SUBJECT: Forwards hardship exemption request for accepting as is
 sacrificial shield wall weld defects identified as being in
 violation of AWS D1.1, Revisions 1-73 Code. Certificate of Svc
 encl.

Subject: WPPSS NUCLEAR PROJECT NO. 2
HARDSHIP EXEMPTION REQUEST
WNP-2 SACRIFICIAL SHIELD WALL

Hardship Exemption Request
For Acceptance As-Is of
Certain Identified Weld Defects
In The WNP-2 Sacrificial Shield Wall in
Violation of AWS D1.1 (Rev. 1-73)

FIGURE 1

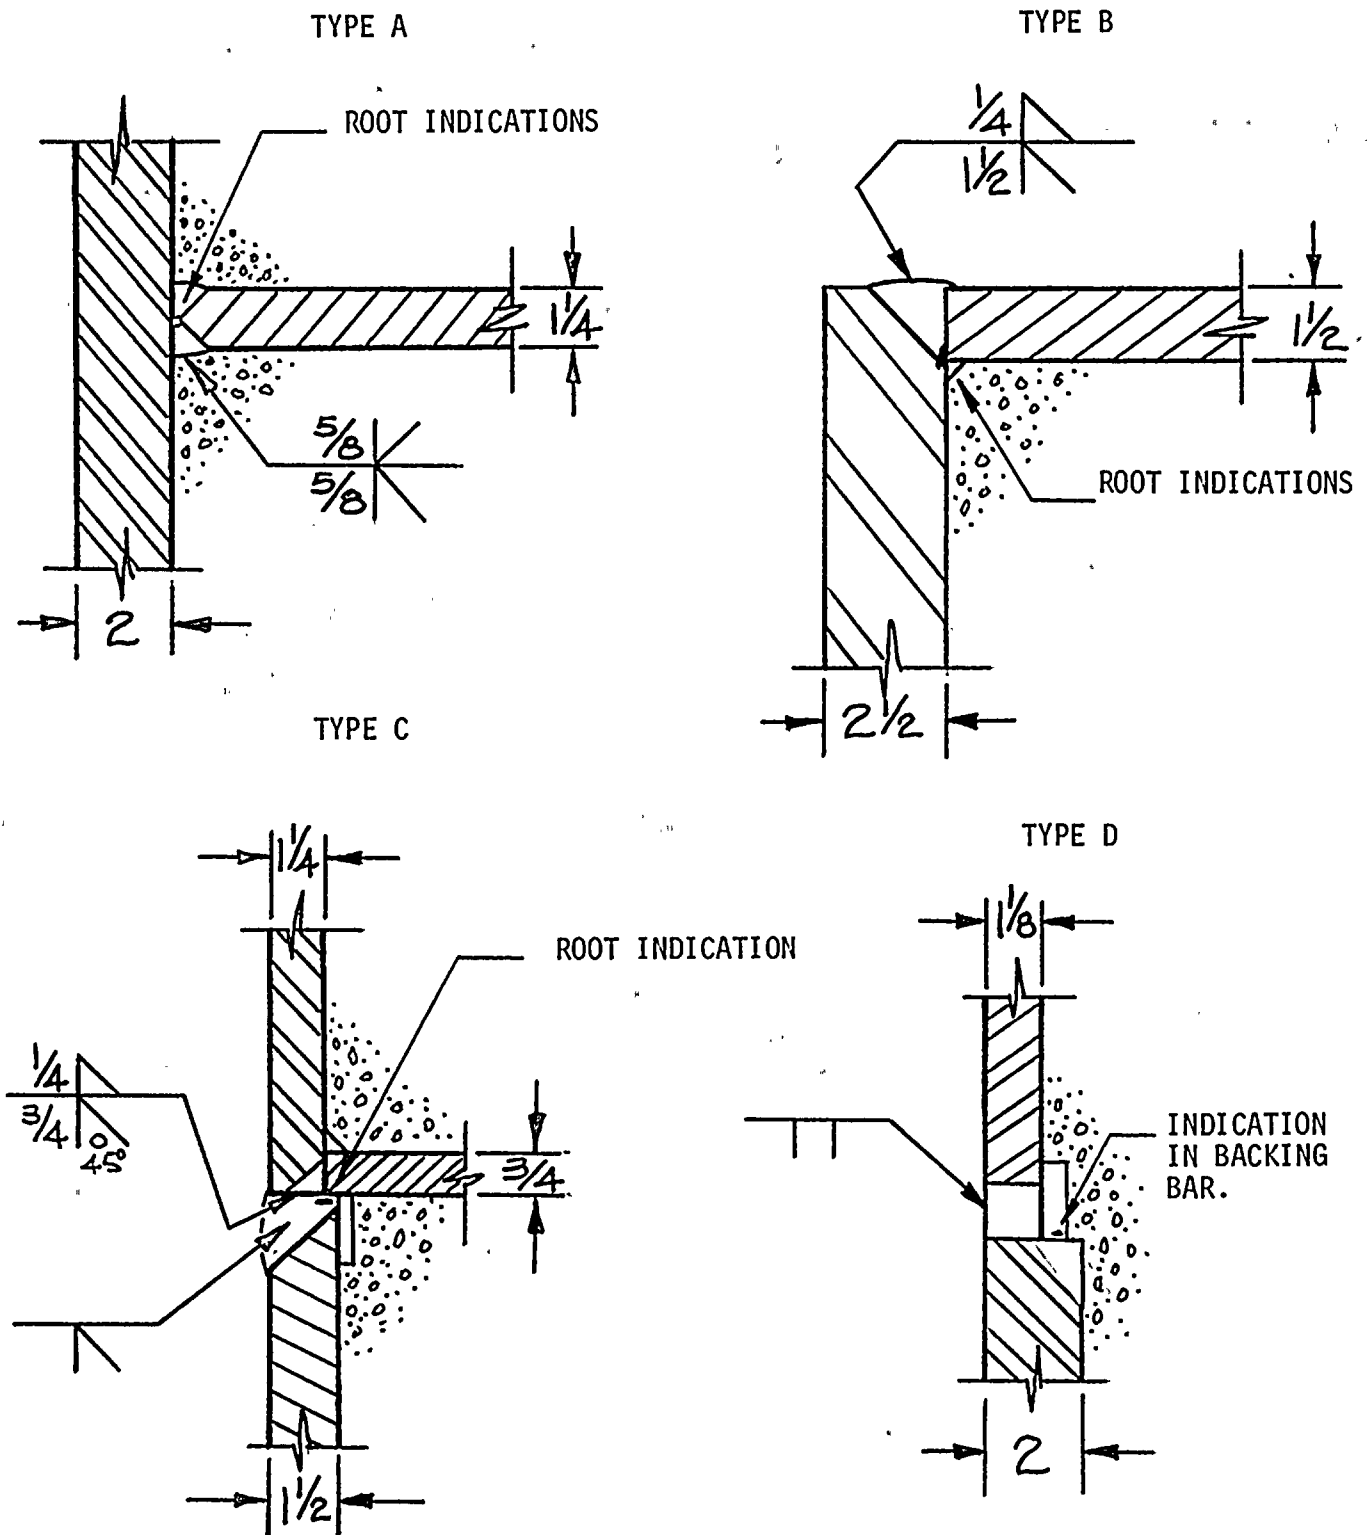
(1) Weld No. W4-65 Weld Type:  SMAW
Weld Location: E1 528' Az 330°
Type Inspection: VT, UT
Defect Description: Incomplete penetration in Type C weld. (Figure 1)

Type Inspection: VT, UT
Defect Description: Incomplete penetration in Type A weld joint. (Figure 1)

Defect Description: Incomplete penetration in
Type A weld joint (Figure 1)

Defect Description: Defect is 15" long with a DB rating of +3 which makes it a large reflector per AWS D1.1 for electroslag welds. Defect is located at 1-5/8" from the outside surface of the SSW. See weld type D (Figure 1).

Defect Description: Incomplete penetration in
Type A weld joint. (Figure 1)

Defect Inspection: Incomplete penetration in Type A
weld joint (Figure 1)

Defect Description: Incomplete penetration in
Type B weld joint. (Figure 1)

Defect Description: Incomplete penetration in Type B
weld joint (Figure 1)

Defect Description: Incomplete penetration in Type A weld joint (Figure 1)

Defect Description: Incomplete penetration in Type A weld joint (Figure 1)

1. Only 12" of weld is accessible - remainder of weld is behind attachments or behind skin plates.
2. Repair would require removing attachments and skin plates, cutting through wall, chipping concrete, installing backing plate and rewelding.
3. Nature of defect does not warrant such extensive rework with potential for creating serious defects.

1. Of total weld length of 2'7" only 1'5" is accessible. The remainder is behind a pipe whip restraint.
2. To repair the accessible part it would be necessary to excavate through the wall into the stiffener plate.
3. Nature of the defect does not warrant such extensive rework with a potential for creating serious defects.
4. Access is limited by a main steam line which is 15" from the SSW.

1. Of total weld length 2'7" only 1'5" is accessible. The remainder is behind a pipe whip restraint.
2. To repair the accessible part it would be necessary to excavate through the wall into the stiffener plate.
3. Nature of the defect does not warrant such extensive rework with a potential for creating serious defects.
4. Access is limited by a main steam line which is 15" from the SSW.

1. Of 20" total length of weld, 16" is accessible. Remainder lies behind skin plates.
2. Defect apparently not in weld but in backing bar.
3. Removal would require cutting through wall and removing skin plates.
4. Nature of defect does not warrant such extensive repair with potential for creating serious defects.
5. Access is limited by main steam line which is 15" from the wall.

1. Weld is 2'8-1/2" long. Only 12" are accessible.
Remainder is behind a pipe whip restraint.
2. To repair the accessible part it would be necessary
to excavate through the wall into the stiffener
plate.
3. Nature of defect does not warrant such extensive
rework with a potential for creating serious
defects.

1. Weld is 2'8-1/2" long. Only 12" are accessible.
Remainder is behind a pipe whip restraint.
2. To repair the accessible part it would be necessary
to excavate through the wall into the stiffener
plate.
3. Nature of defect does not warrant such extensive
rework with a potential for creating serious
defects.

1. Repair would require extensive gouging and grinding with potential for cutting through wall. Rewelding would require extensive preheating of a highly restrained area (per criteria of Table 1).
2. Half of the weld is highly restrained being only 2-1/2" from large pipe whip restraints.
3. Nature of defect does not warrant such extensive repair with potential for creating serious defects.

1. Repair would require extensive gouging and grinding with potential for cutting through wall. Rewelding would require extensive preheating of a highly restrained area (per criteria of Table 1).
2. Half of the weld is highly restrained being only 2-1/2" from large pipe whip restraints.
3. Nature of defect does not warrant such extensive repair with potential for creating serious defects.

1. Of 2'6" total length of weld only 1'3" are accessible. The remainder is behind a pipe whip restraint.
2. To repair the accessible part it would be necessary to excavate through the wall into the stiffener plate.
3. Nature of defect does not warrant such extensive rework with a potential for creating serious defects.

1. Of 2'7" total length of weld, only 1'4" are accessible. The remainder is behind a pipe whip restraint.
2. To repair the accessible part, it would be necessary to excavate through the wall into the stiffener plate.
3. Nature of defect does not warrant such extensive rework with a potential for creating serious defects.
4. In addition repair access is limited by a 13" OD vertical pipe running 15" from the SSW.

Figure 3
Porosity Detail

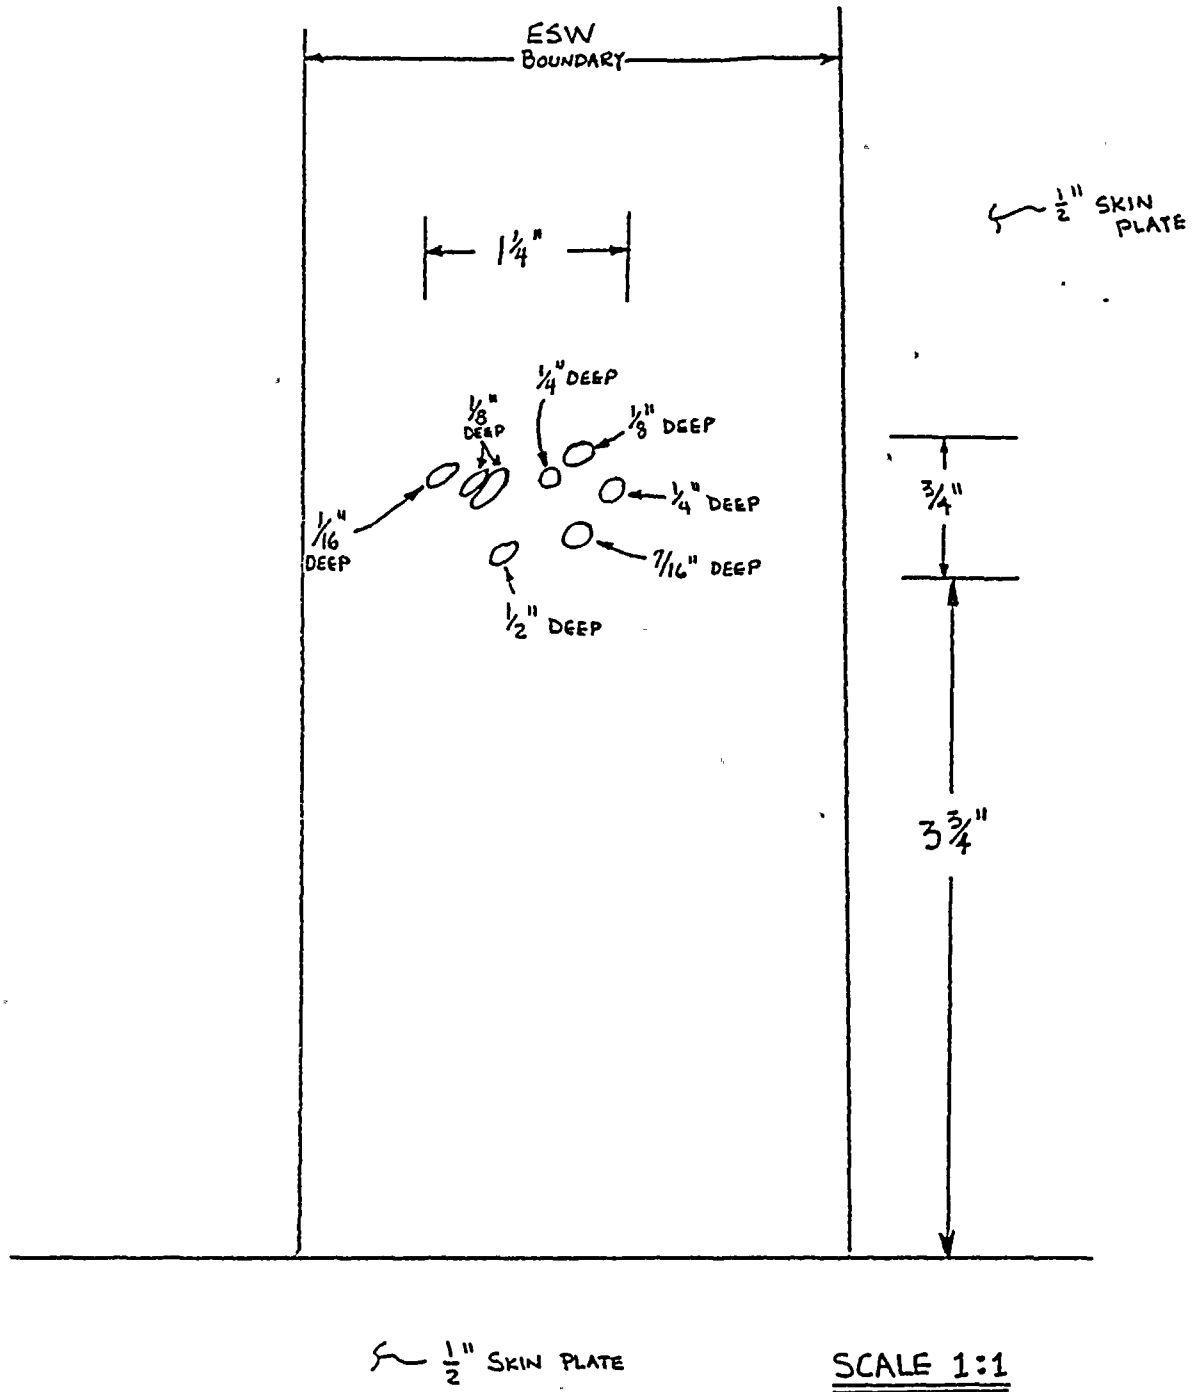
- (5) Weld No.: W23-24 Weld Type: Vertical Electroslag
Weld Location: E1 533' Az 160°
Type Inspection: VT
Defect Description: Porosity - See Figure 3 for detail.
Justification for Hardship:

Repair will possibly require excavation through thickness of electroslag weld to remove porosity. This will require chipping of concrete, fitting of backing plate and rewelding. Also if pores extend along length of weld, skin plates will have to be removed and weld excavated.

The nature of this defect does not warrant repair since the extensive nature of this repair increases risk of generating more serious defects.
